ONSITE SEWAGE DISPOSAL SYSTEM

PROPERTY ADDRESS: 4807 River Crossing Court

SUBDIVISION: Homewood Crossing

From: Geisert, Andrew
Sent: Monday, May 05, 2014 3:58 PM
To: 'mboyce@eseeng.com'
Subject: Homewood Crossing Lot 71 BAT Plan review

PLOT PLAN FOR BAT INSTALLATION
LOT 71
HOMEWOOD CROSSING
LIBER 9808, FOLIO 204
PLAT No. 18243
TAX No. 05-443369
FIFTH ELECTION DISTRICT
HOWARD COUNTY, MARYLAND
ADDRESS: 4807 RIVERCROSSING COURT
ELLICOTT CITY, MARYLAND

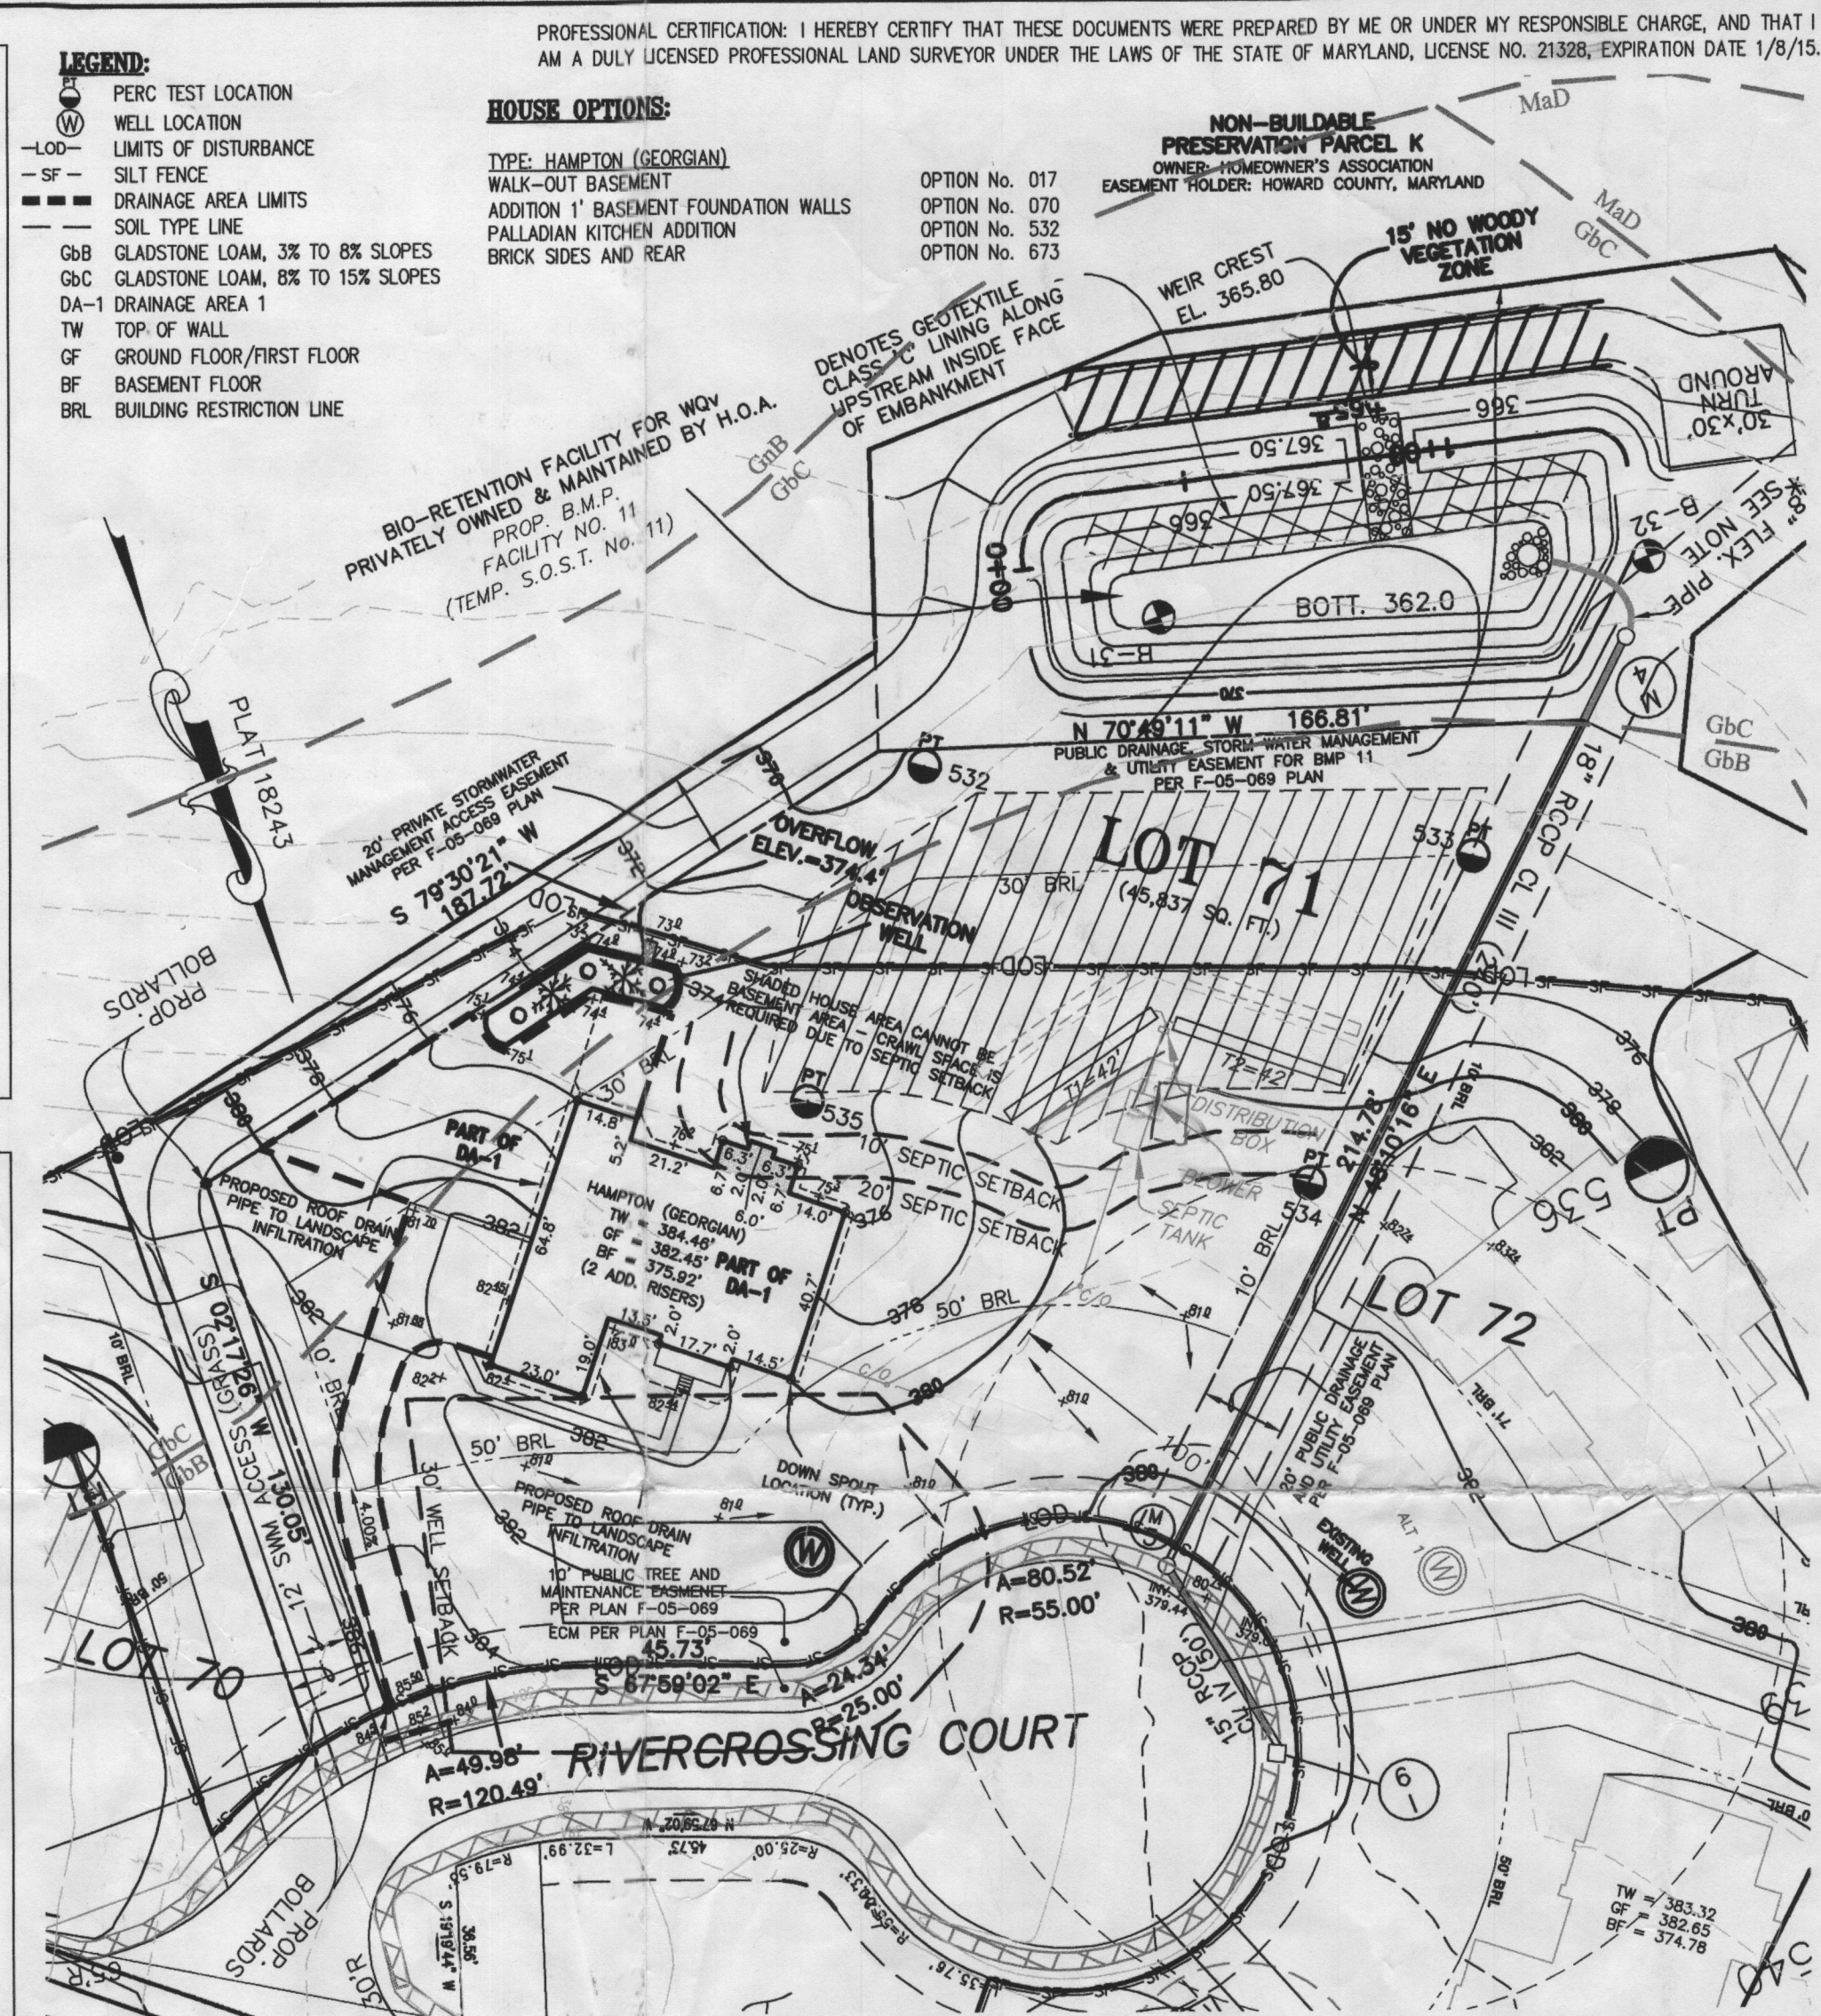
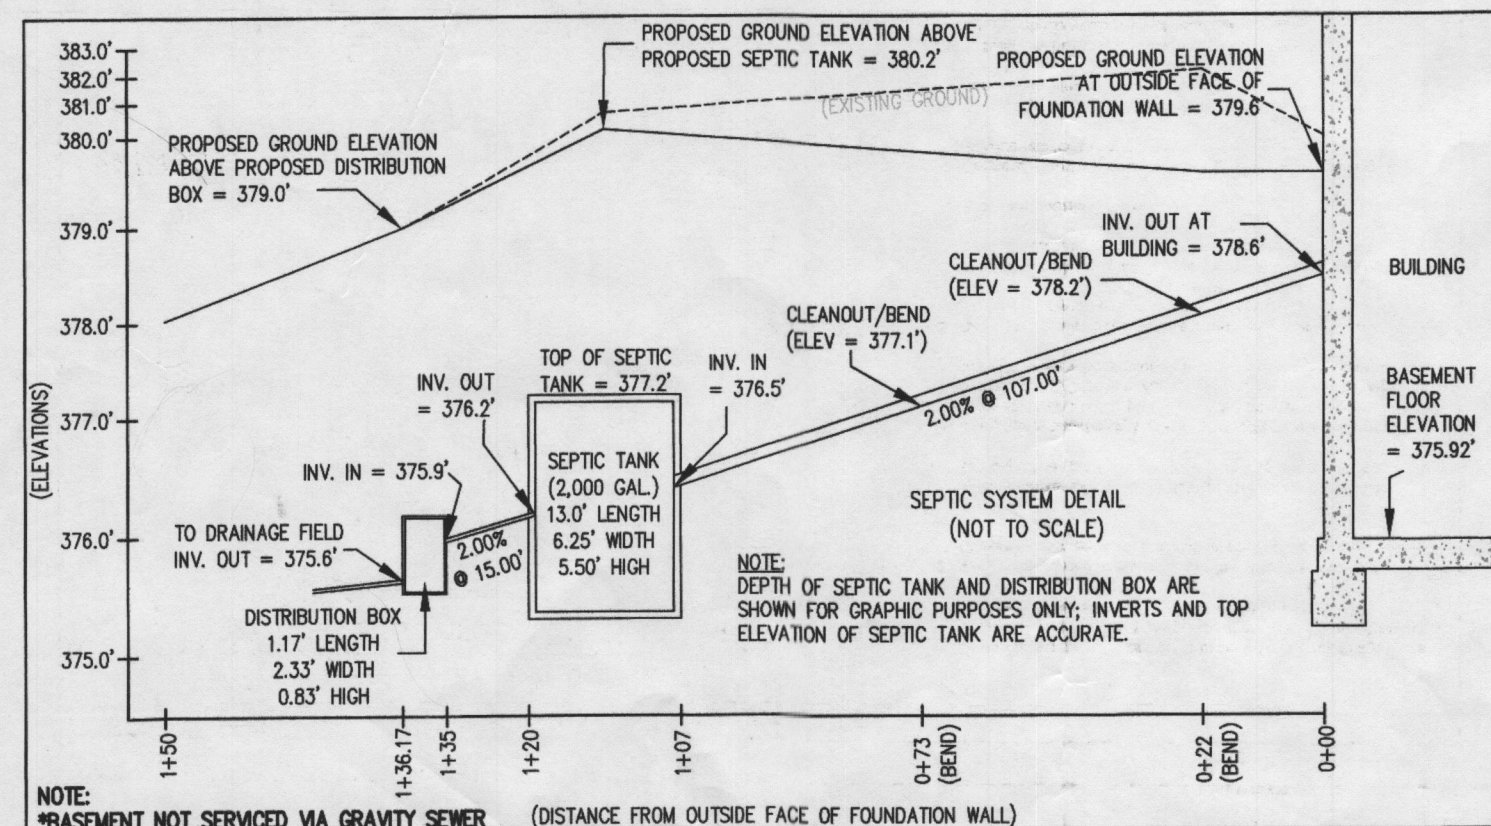
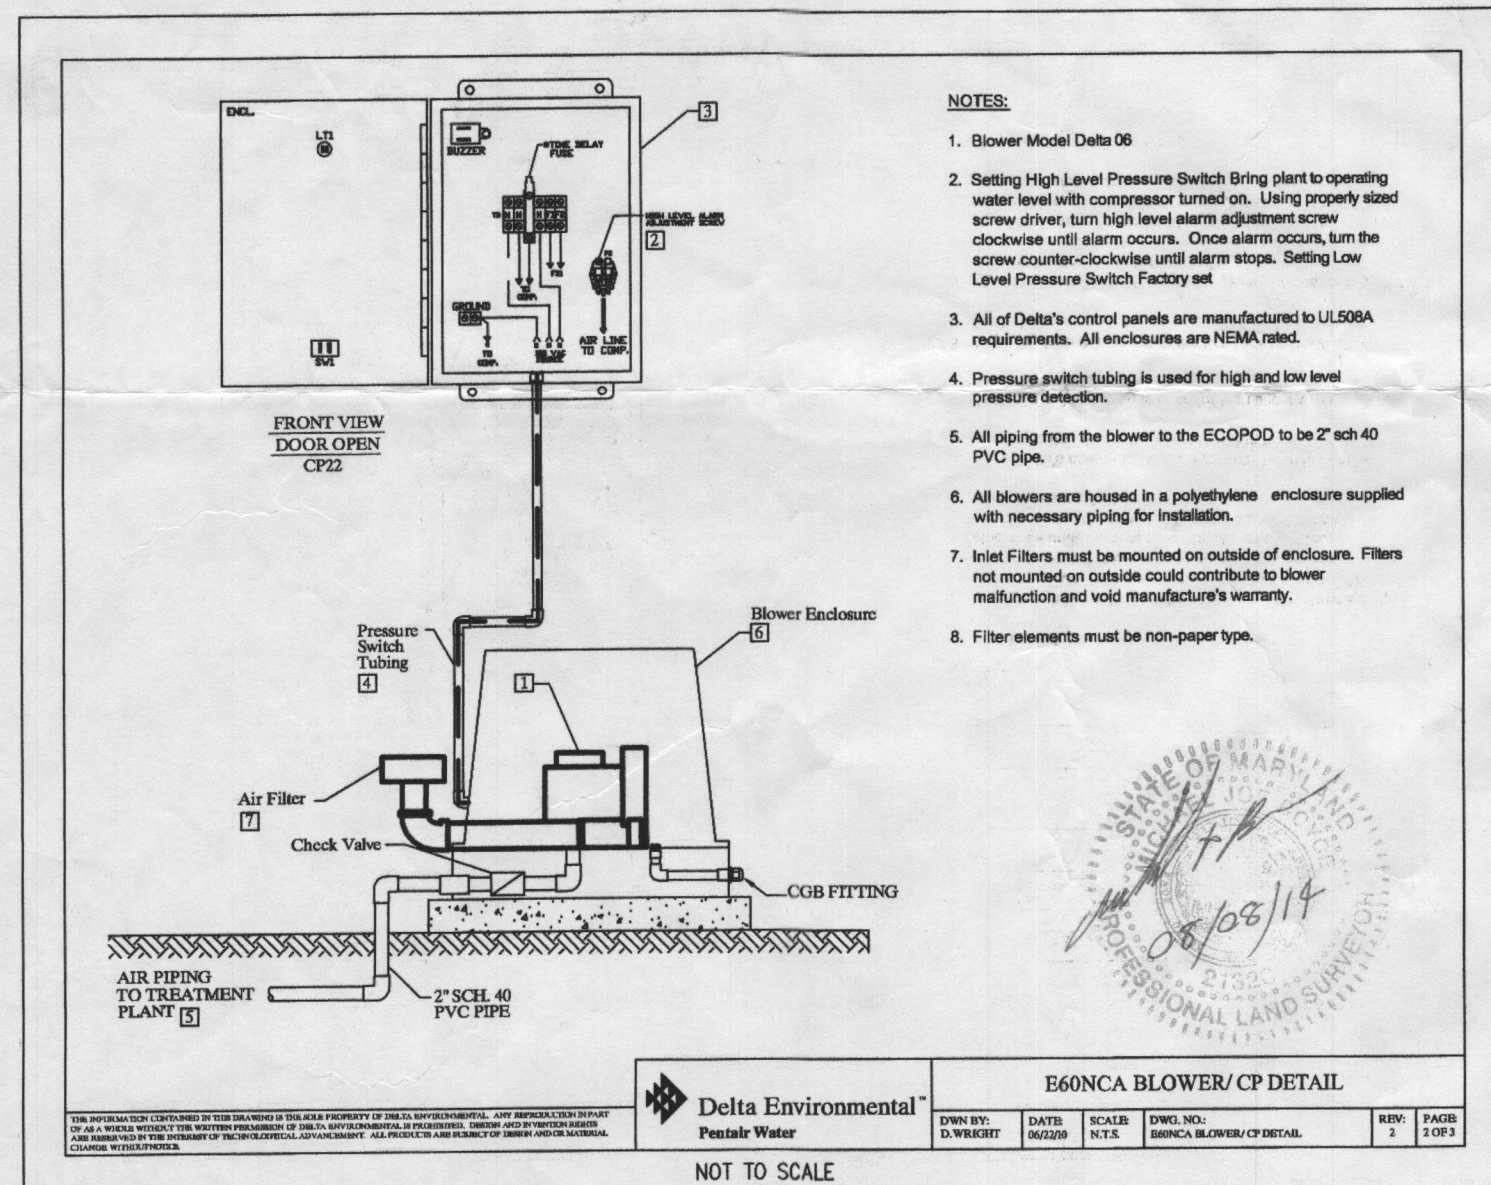
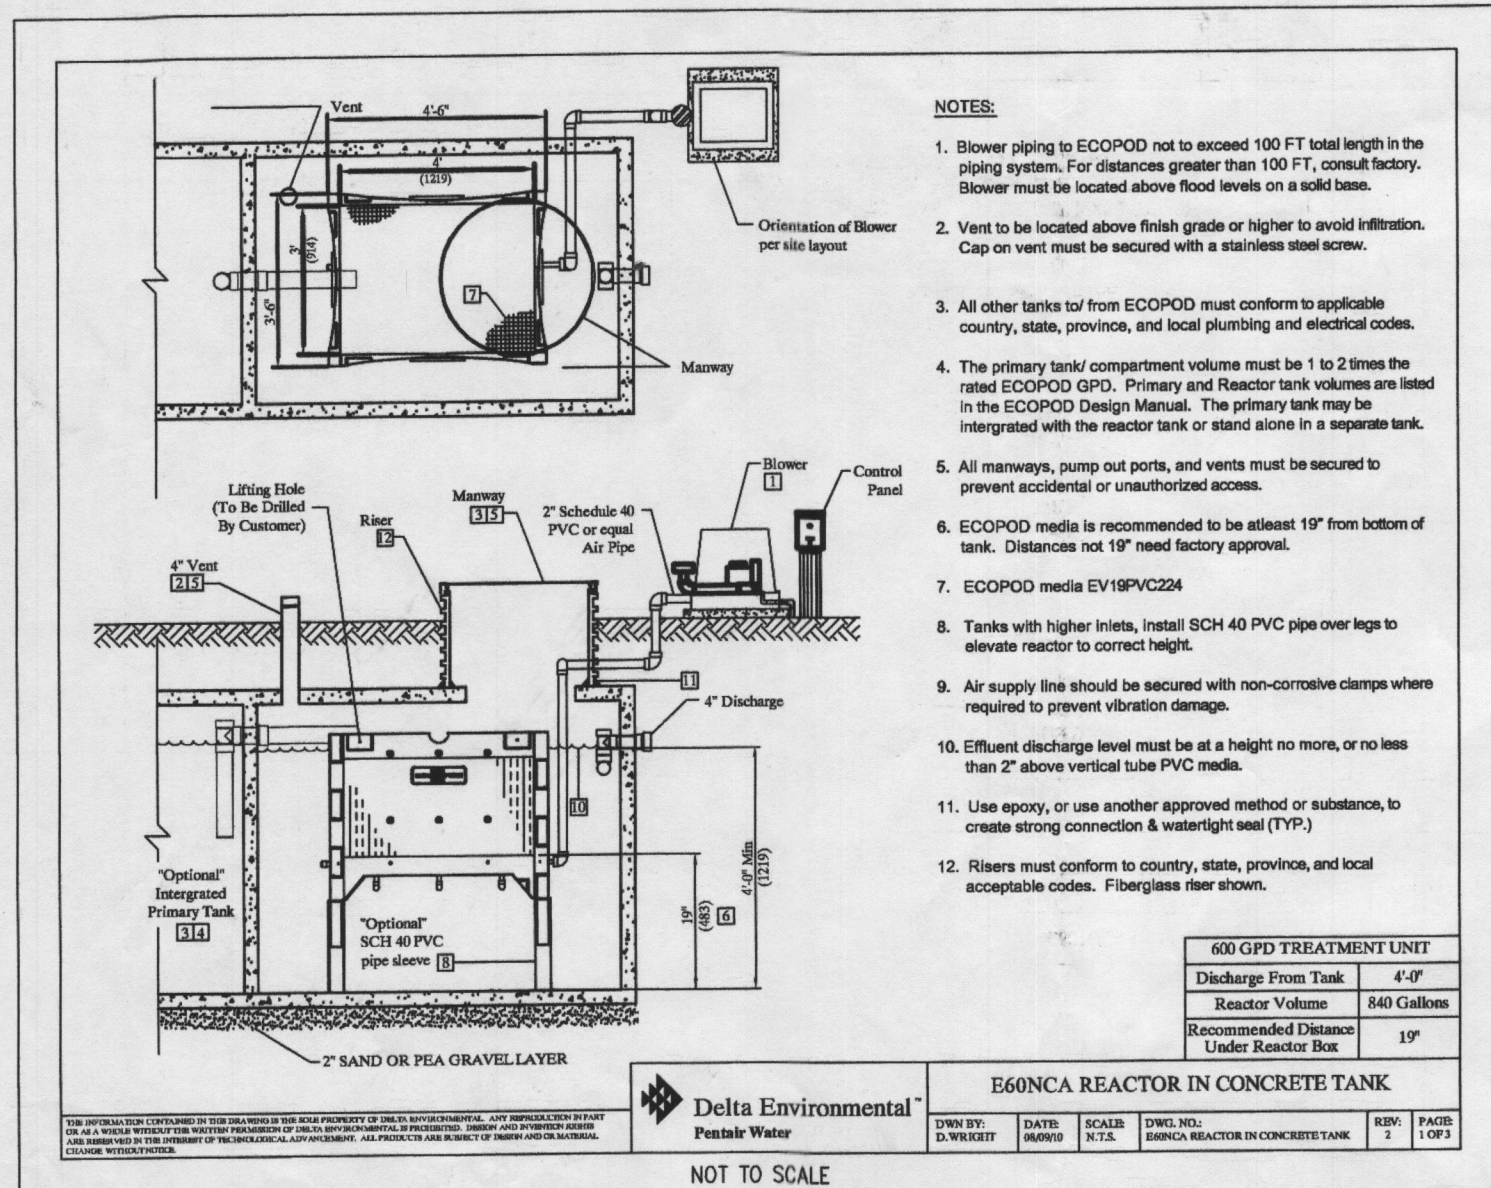
- Only a TRUE deck can be within 20 feet of a sewage disposal area. Even a portion of the house on a crawl space must maintain a 20 foot setback from the easement. Please adjust the location of the house to maintain a 20 septic setback and still maintaining a 30 foot well setback.

I spoke with Mike following your e-mail response. A 10 foot setback will work for the crawlspace.
